BCA ASSESSMENT REPORT

2 Sydenham Road, Brookvale

Project Number: 119271
Report Type: BCA
Revision: 2
Date: 12 September 2024

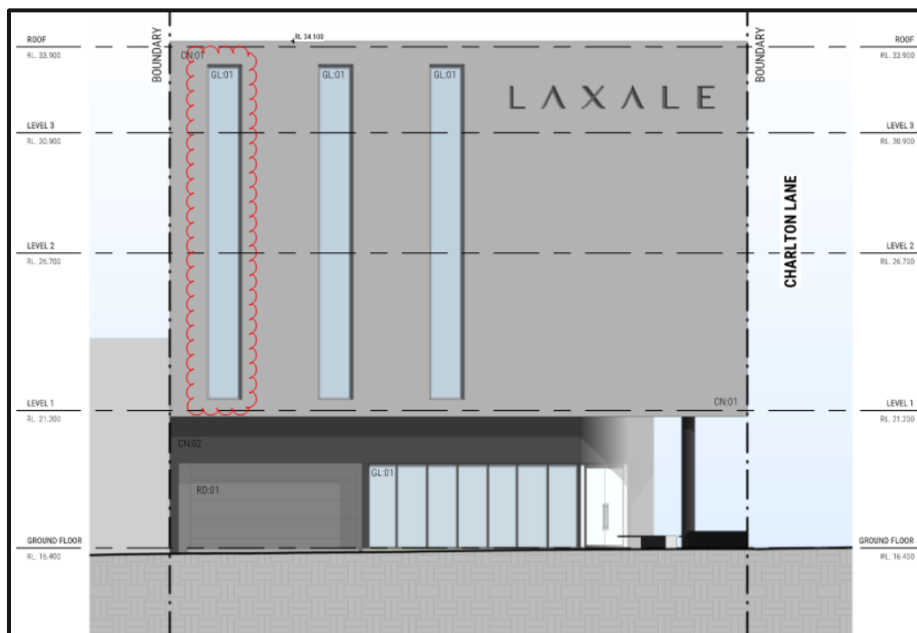
The Class 6 and 7b portion of the building have been assessed and the floor area and volume of these compartments is less than that permitted by BCA Clause C3D3. As such compliance with the provisions of the BCA for compartmentation is readily achieved, however this assessment is to be reaffirmed at Construction Certificate stage once holistic fire compartment drawings are available for assessment.

The development is Type A Construction and BCA Clause C3D7 requires suitable vertical and/or horizontal spandrel separation between the openings in the external walls on different storeys. The plans indicate spandrels are not provided on the northern elevation due to the proposed glazing which does not achieve a minimum of 900mm high spandrel.

3.4.1 Openings in external walls

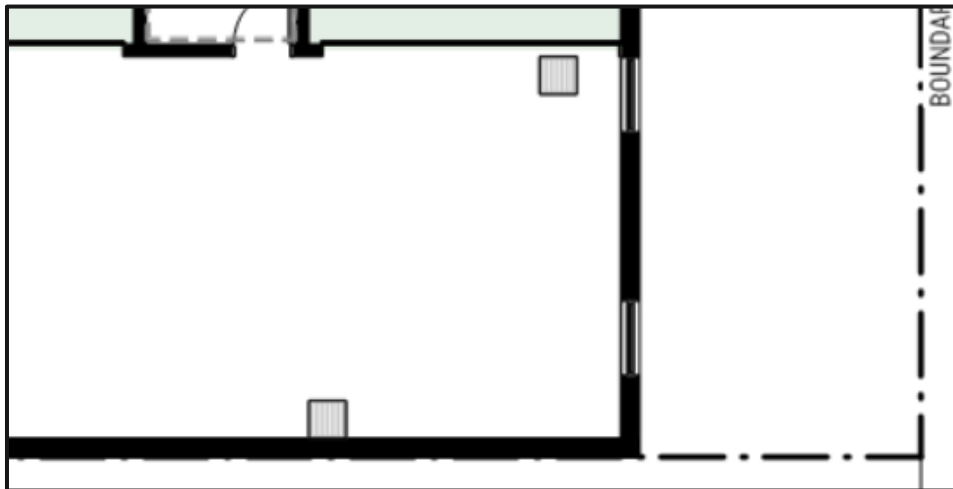
The window opening on the northern elevation are within three (3) metres of the boundary and will require protection. Protection can be provided by self-closing fire windows, fire shutters or fixed glazing with sprinklers. Details are to be provided at Construction Certificate Stage to outline how compliance will be achieved. Where compliance cannot be met, the Fire Safety Engineer will need to review and confirm if a performance solution is feasible.

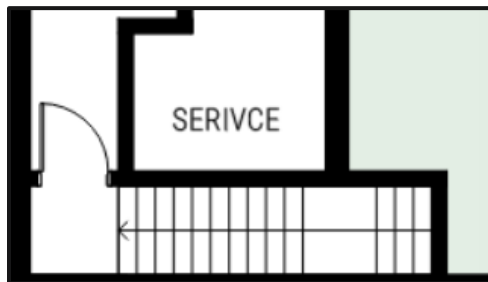
However, there is a fire-isolated exit which discharges internally into the building rather than open to sky which will need to be addressed under a Performance Solution as per BCA D2D12, the following area includes the South-eastern fire-isolated stairway discharges internally within the building.

In addition, the central fire-isolated stairway Service Room opens directly into a fire-isolated passage in lieu of an air lock contrary to the requirements of D2D12.

3.5.2 Access for people with a disability

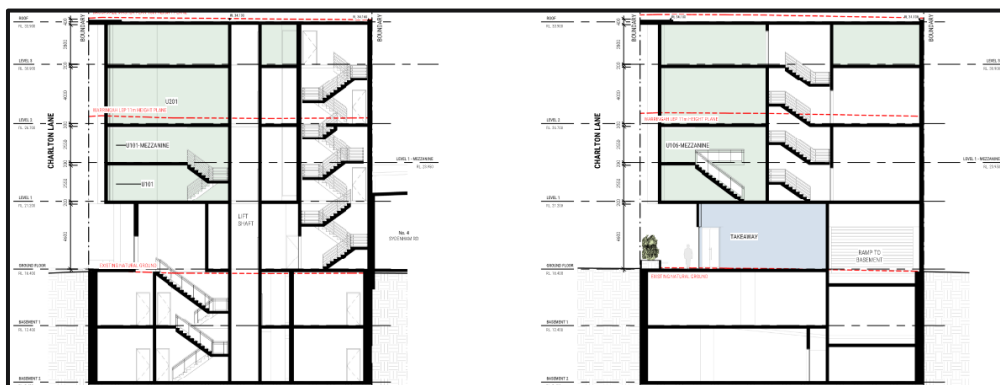
Northern Beaches Council's Pittwater 21 DCP states that 3% of the car parking spaces are required to be accessible parking spaces, there is only one proposed accessible car parking space which is non-compliant. Therefore, an additional accessible car parking space with a shared zone must be provided to comply with Council's DCP and BCA D4D6.

A clear space of 1540x2070mm are required in front of lift lobbies to provide a clear turning space for wheelchairs. The lift lobby on Basement 1 does not have a clear 1540x2070mm space and therefore is non-compliant, the drawing plan must be modified to provide a 1540x2070mm clear space as per BCA D4D4.

When there a 90 degree turns within an accessible path of travel, a clear 1500x1500mm turning space with a splayed corner must be provided. The accessible pathway leading to the lift on Basement 1 does not have a clear 1500x1500mm and therefore is non-compliant. The drawing plans must be modified to provide a clear 1500x1500mm turning space to be compliant in accordance with BCA D4D4.
